### Passive Struts - Use on Ride Control Equipped Vehicle

Bulletin No.: 00-03-11-001A

Procedure to Disable Illumination of Service Indicator AFTER the Installation of Passive Struts/Shocks

This bulletin is being revised to clarify when this bulletin may be used to turn the service suspension lamp off. Also, a step has been added to the 1991 Cadillac Eldorado and Seville repair. Please discard Corporate Bulletin Number 00-03-11-001 (Section 3 - Suspension).

OE Page 8a-43-6

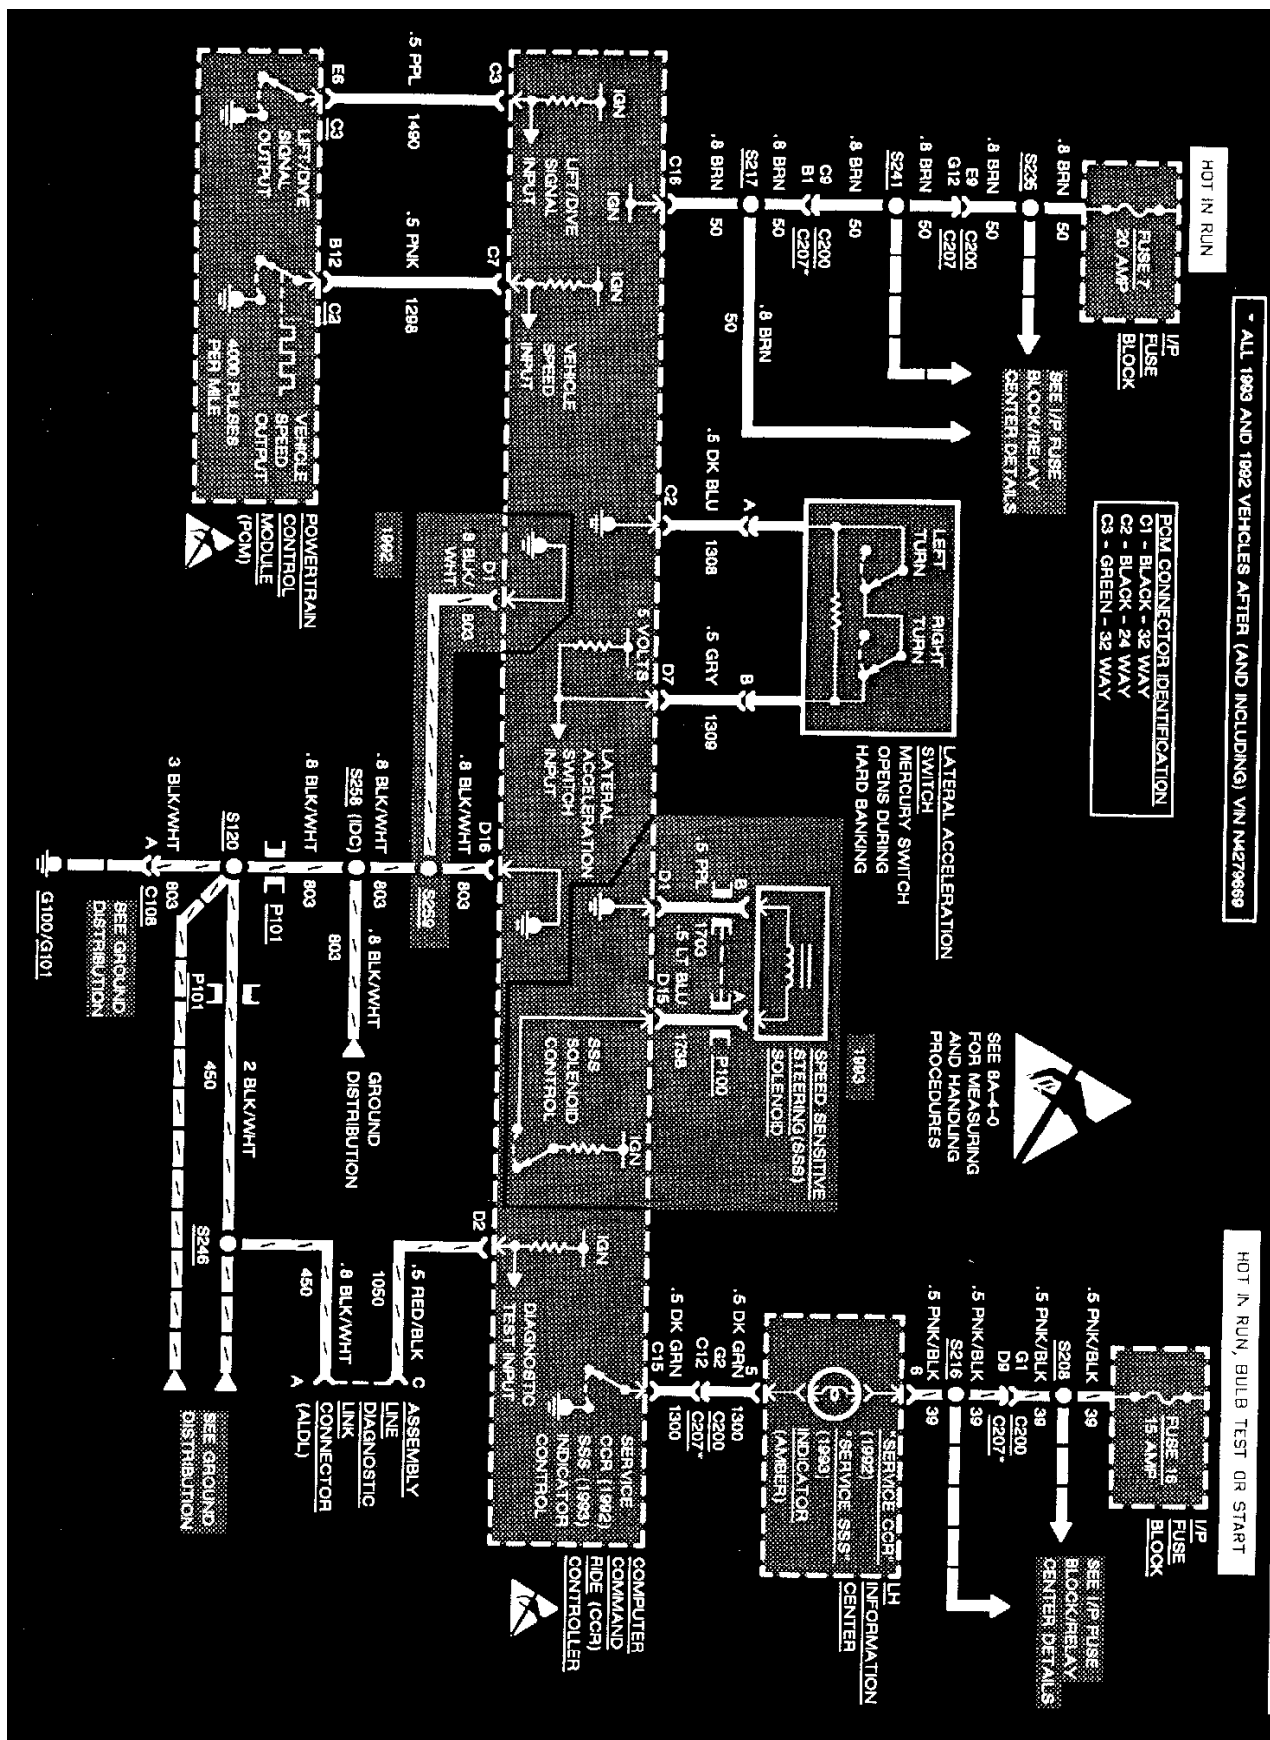
Refer to page 8A-43-6 in the 1992 Eldorado Seville Service Manual.

1. Cut circuit 1020 (PINK).
2. Attach the IPC side of circuit 1020 to relay pin 87A.
3. Attach the module side of circuit 1020 to relay pin 86.
4. Run a ground wire to relay pin 30.

5. Run a wire from a switched ignition (hot in Run) source to relay pin 85.

Computer Command Ride Control (Part 1 Of 2)

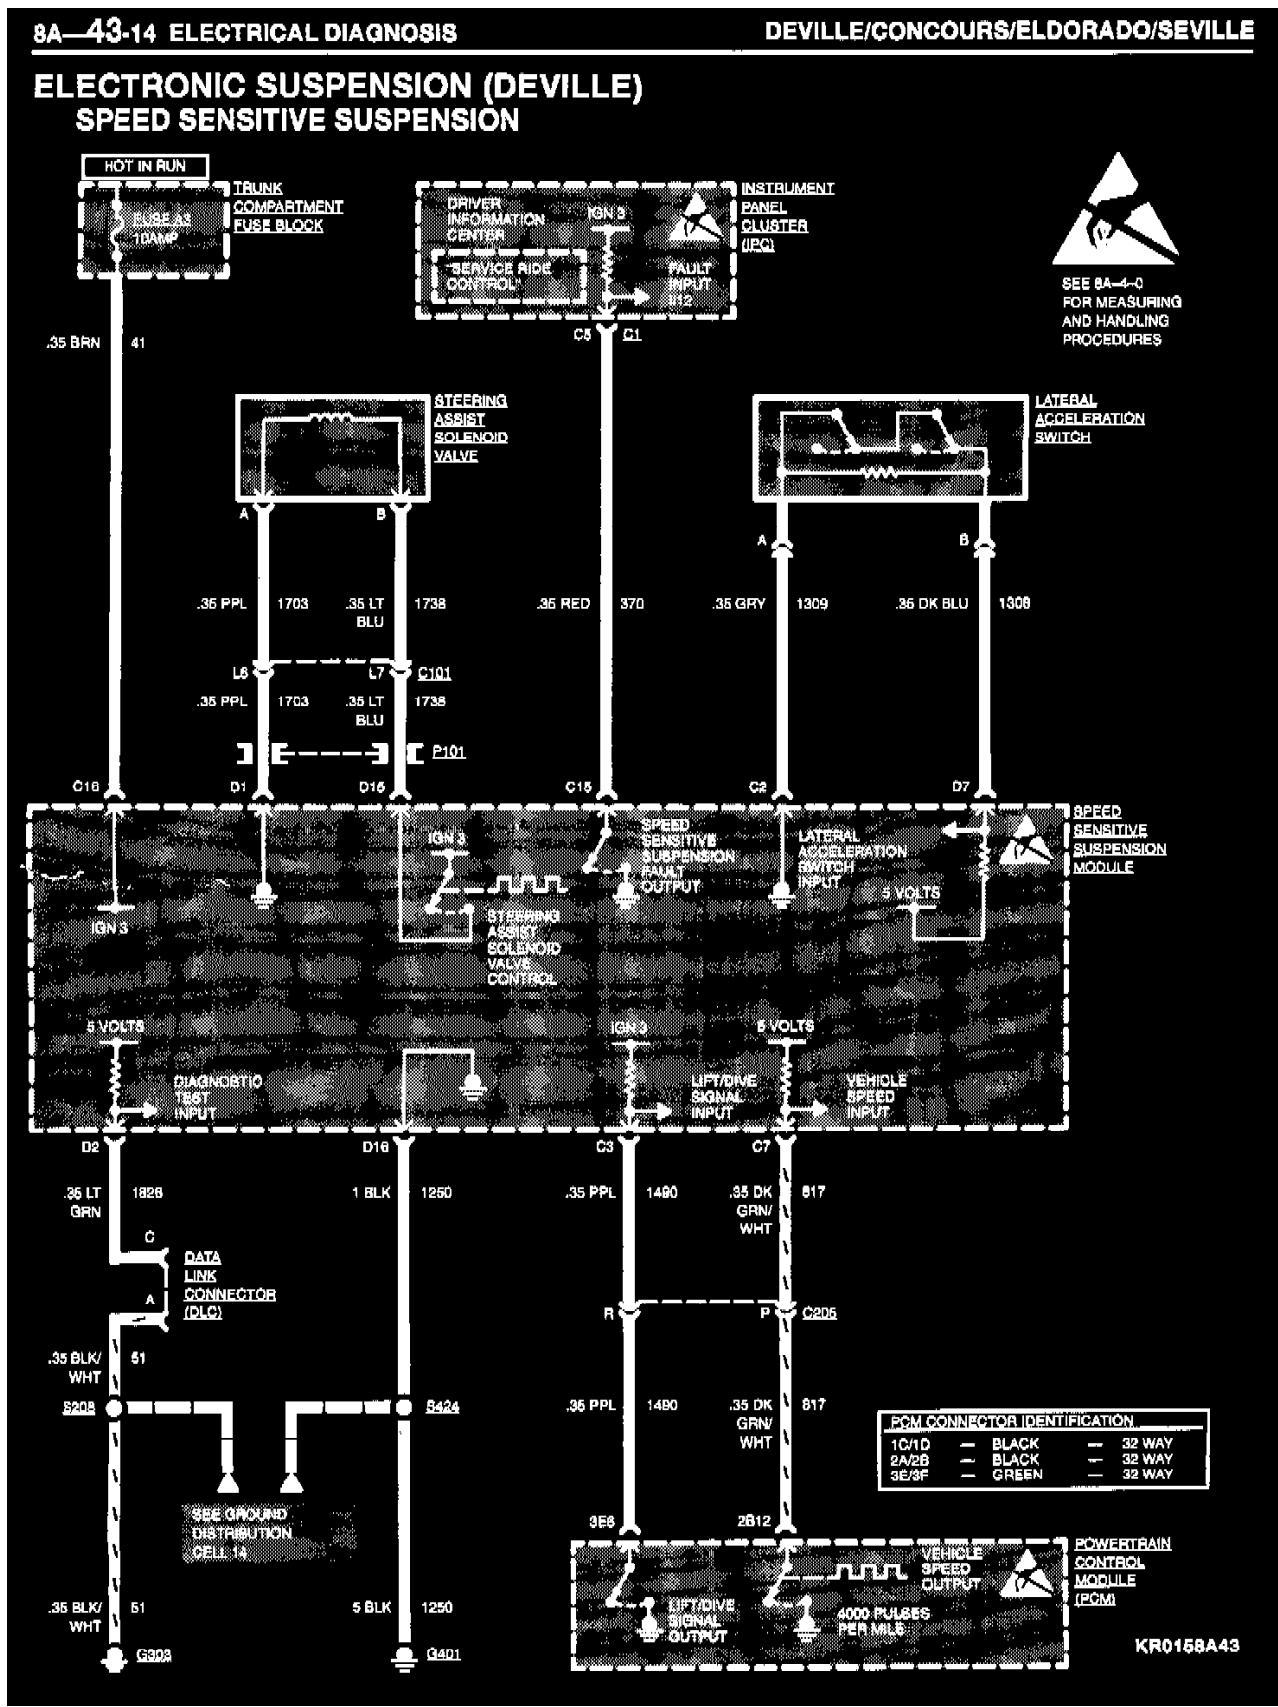
Refer to the Service Manual, page 8A-43-0. Cut Circuit 1300 (Dark Green wire) at the CCR module (Pin C15) to disable the indicator lamp. Tape the wires back into the harness to prevent shorting to other components.
